ADDENDUM TWO

Addendum Two to the drawings and specifications prepared by Myszak + Palmer for **Linton Sports Support Facility** for **Linton Stockton School Corporation**, Linton, Indiana.

C3.0
SITE UTILITY PLAN - SOUTH

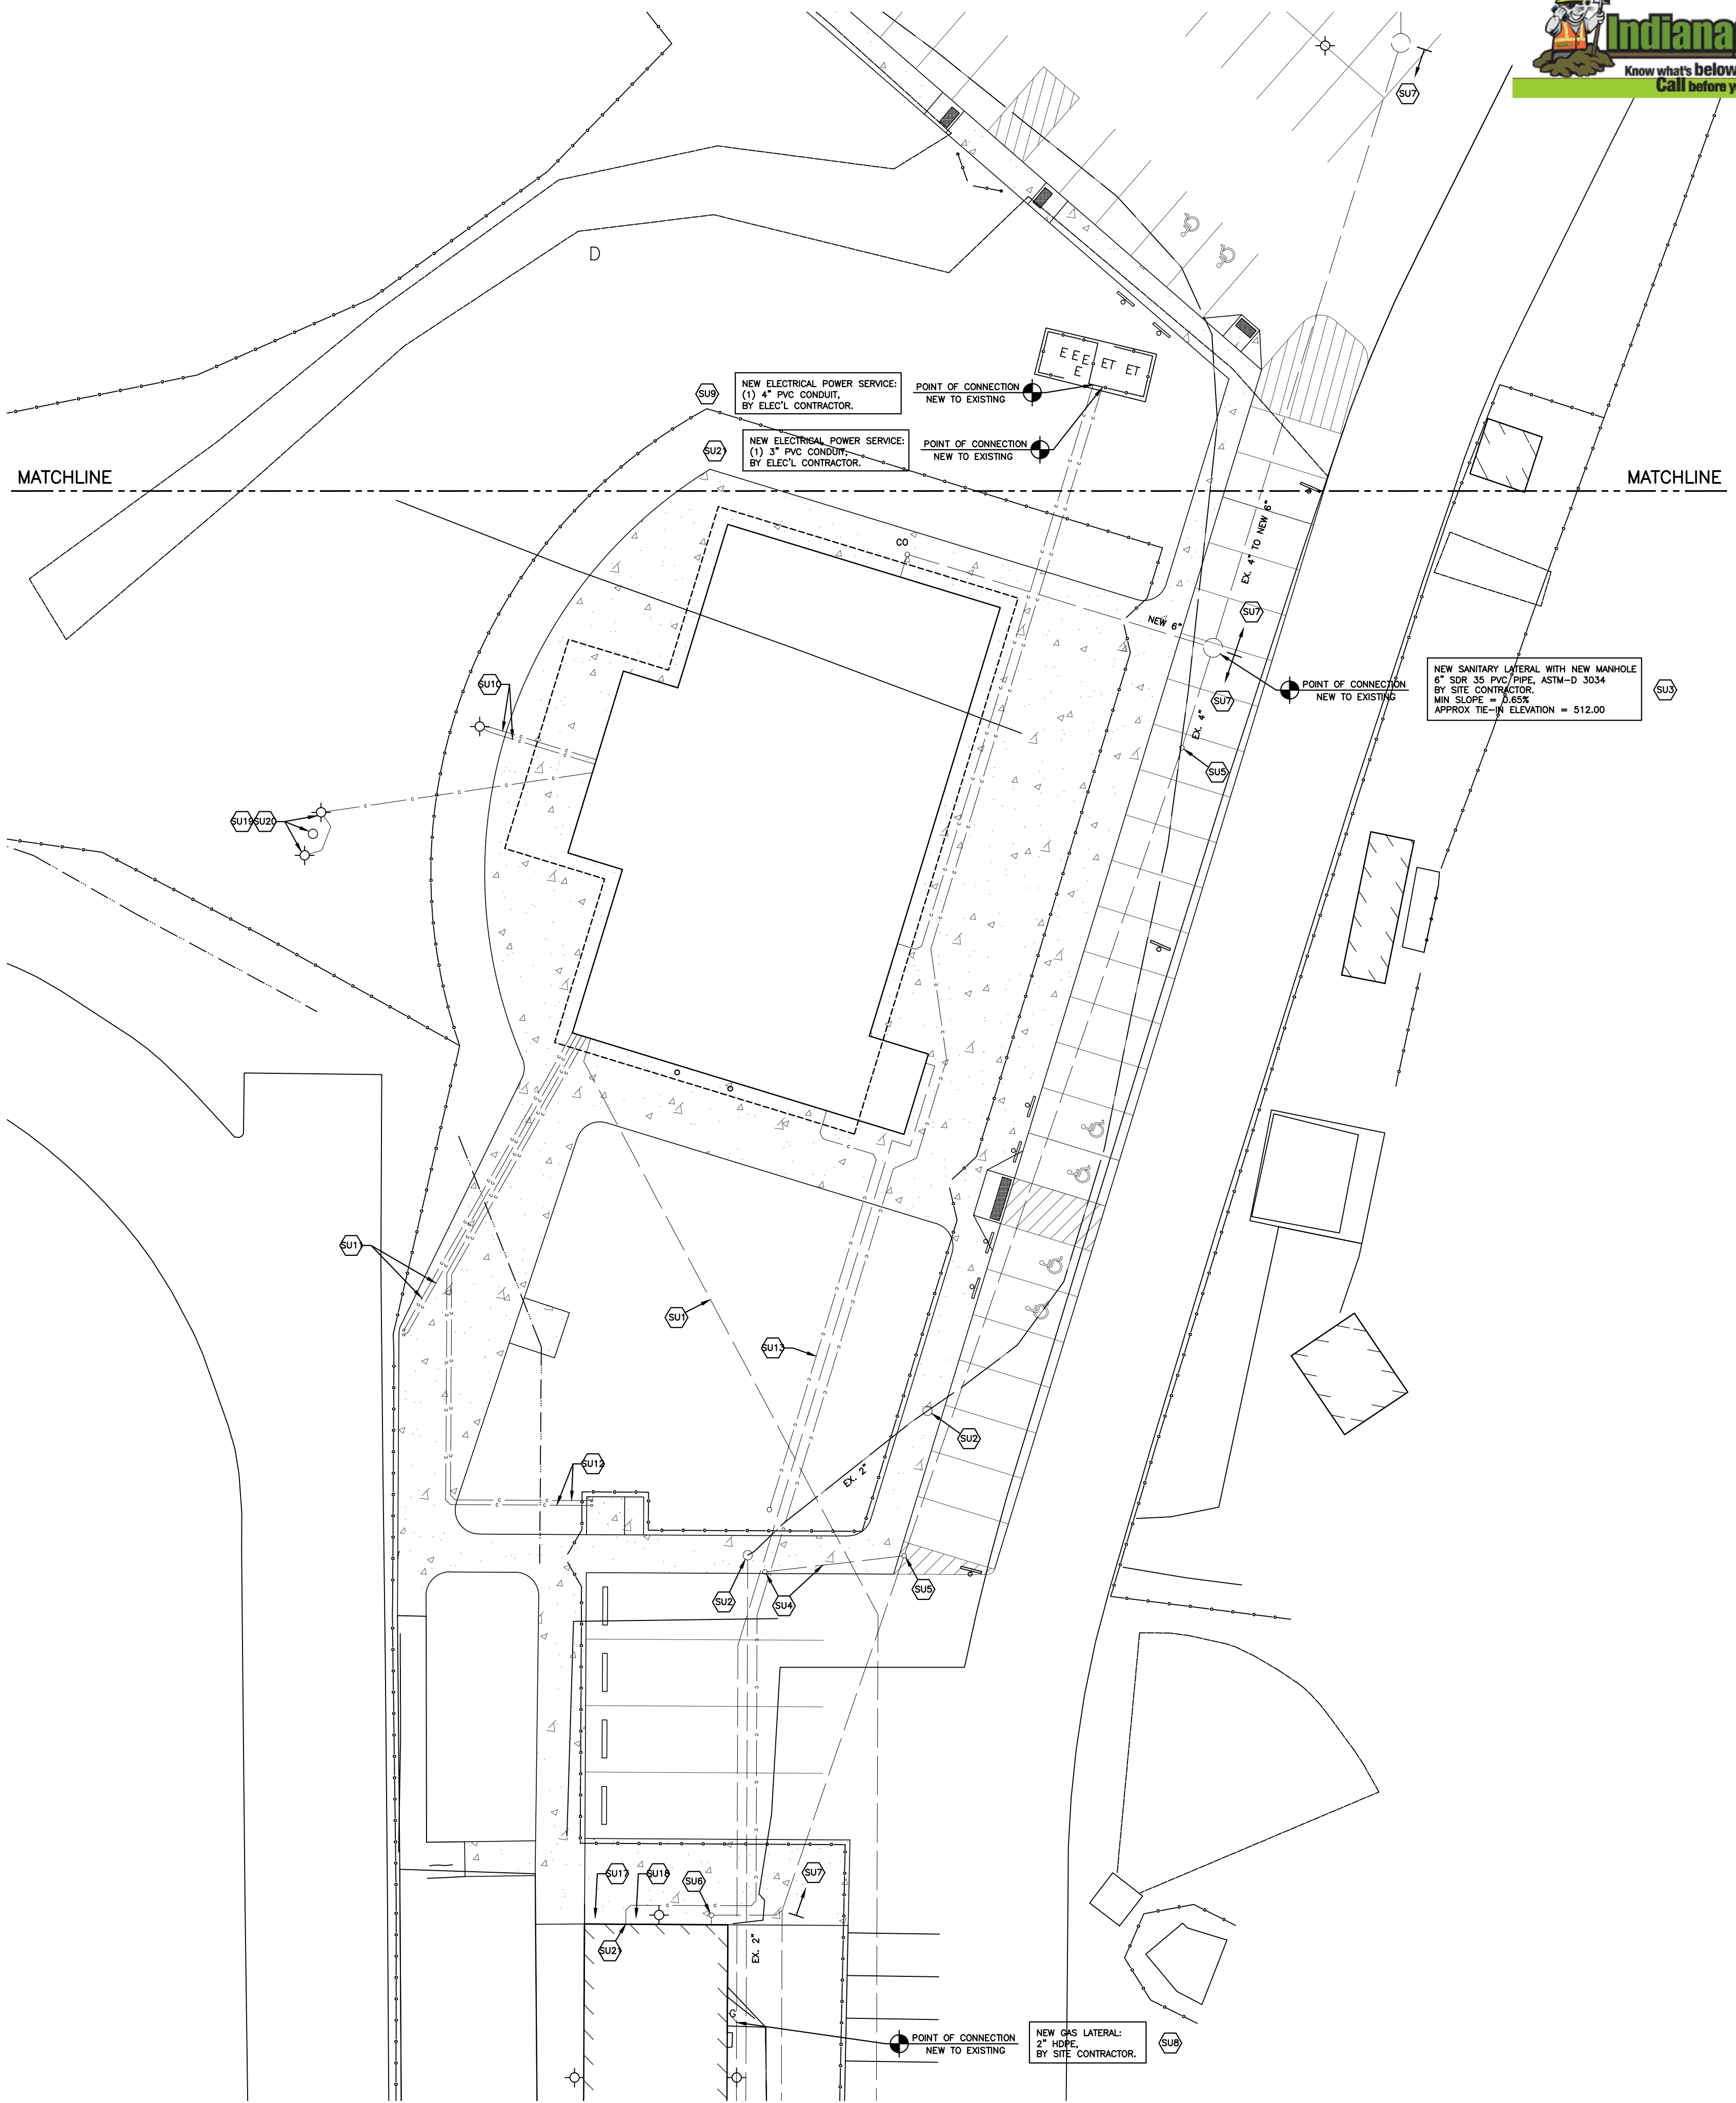
- A. Revised water supply piping size, material, route, and tie-in location are shown on revised sheets C3.0 & C3.1.

- SU1 NEW 3" HDPE DOMESTIC WATER LINE - APPROX 860 L.F. - INSTALLED VIA HORIZONTAL DIRECTIONAL DRILLING BY SITE CONTRACTOR. SITE CONTRACTOR SHALL BE RESPONSIBLE FOR EXCAVATION, INSTALLATION, BACKFILLING & COMPACTION, AND SURFACE RESTORATION. SITE CONTRACTOR SHALL BE RESPONSIBLE FOR ANY UTILITY FOOTING REPAIR DEEMED NECESSARY & SUBSEQUENT ASPHALT. COORDINATE INSTALLATION WITH ALL TRADES, UTILITIES, & OWNER.
